V2500 Propulsion System — Nacelle

Subject: Transmittal of Revision 1 to Service Bulletin Number
V2500-NAC-78-0104

NACELLE - EXHAUST - TAIL CONE -INTRODUCTION OF PERIODIC
INSPECTIONS FOR CRACKING

V2500-NAC-78-0104

Tail Cone Inspection Criteria
Figure 1

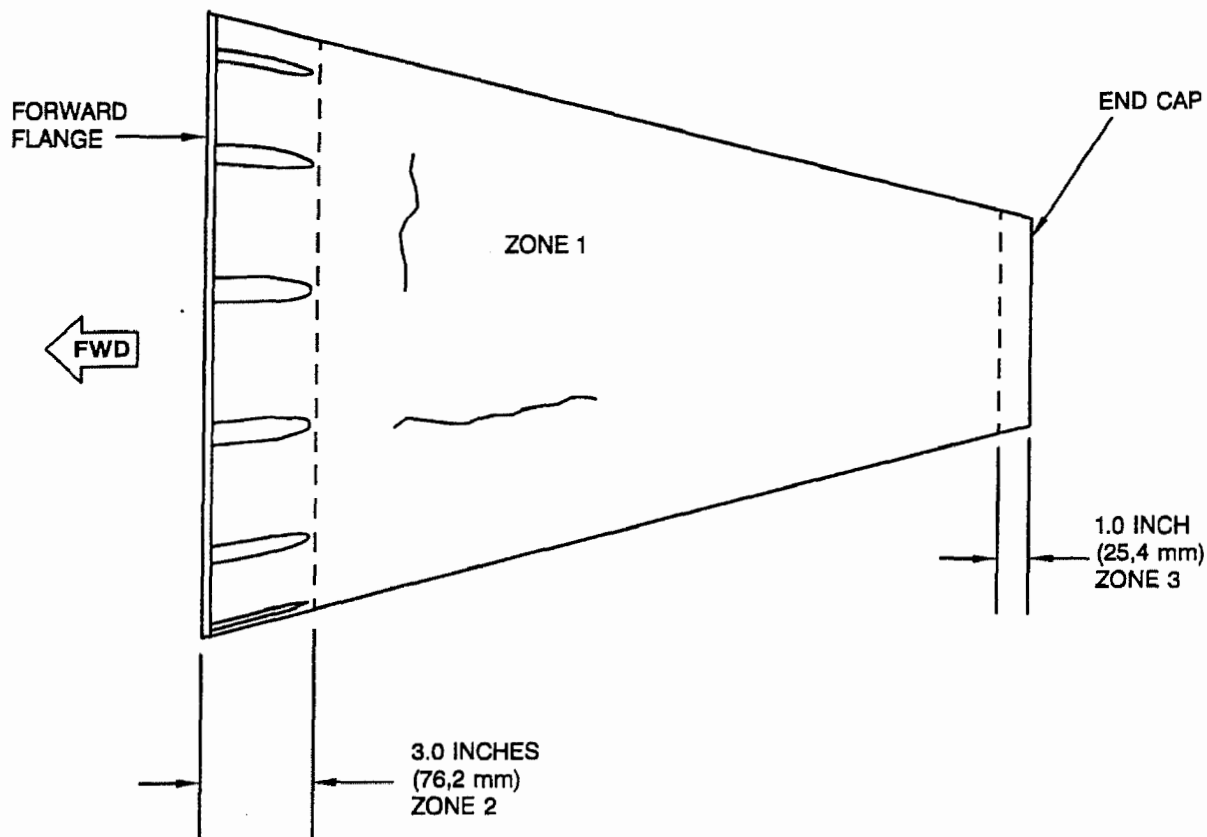
- (1) Visually inspect 290-1501-501 tail cone for cracks in zones 1, 2, and 3. Refer to Figure 1.
- (2) If no cracks are found, tail cone is acceptable for further service.
- (3) If cracks are found, use the following criteria for disposition:

<ol style="list-style-type: none">(a) Zone 1 - any length axially or less than 1.00 in. (25,4 mm) long circumferentially	<p>Acceptable. Re-inspect at next A-check and repair at next C-check per VRS2414. Refer to MD90/V2500D5 Exhaust Cone Component Maintenance Manual, CMM-EC-V2500-3IA</p>
--	---

- (b) Zone 1 - Circumferential cracks more than 1.00 in. (25,4 mm)
- Repair tail cone per VRS2414. Refer to MD90 / V2500D5 Exhaust Cone Component Maintenance Manual, CMM-EC-V2500-3IA.

- (c) Zone 2 -less than 0.50 in. (12,7 mm) from forward flange or more than 1.00 in. (25,4 mm) circumferentially
- Repair per VRS2414. Refer to MD90/V2500D5 Exhaust Cone Component Maintenance Manual CMM-EC-V2500-3IA.

- (d) All other cracks in Zone 2.
- Acceptable. Re-inspect at next "A" check and repair at next "C" check per VRS2414. Refer to MD90 / V2500D5 Exhaust Cone Component Maintenance Manual, CMM-EC-V2500-3IA.

- (e) Zone 3 -if crack reaches the end cap.
- Repair per VRS2414. Refer to MD90/V2500D5 Exhaust Cone Component Maintenance Manual, CMM-EC-V2500-3IA.
- (f) All other cracks in zone 3.

- Acceptable. Re-inspect at next "A" check and repair at next "C" check per VRS2414. Refer to MD90 /V2500D5 Exhaust Cone Component Maintenance Manual, CMM-EC-V2500-3IA.
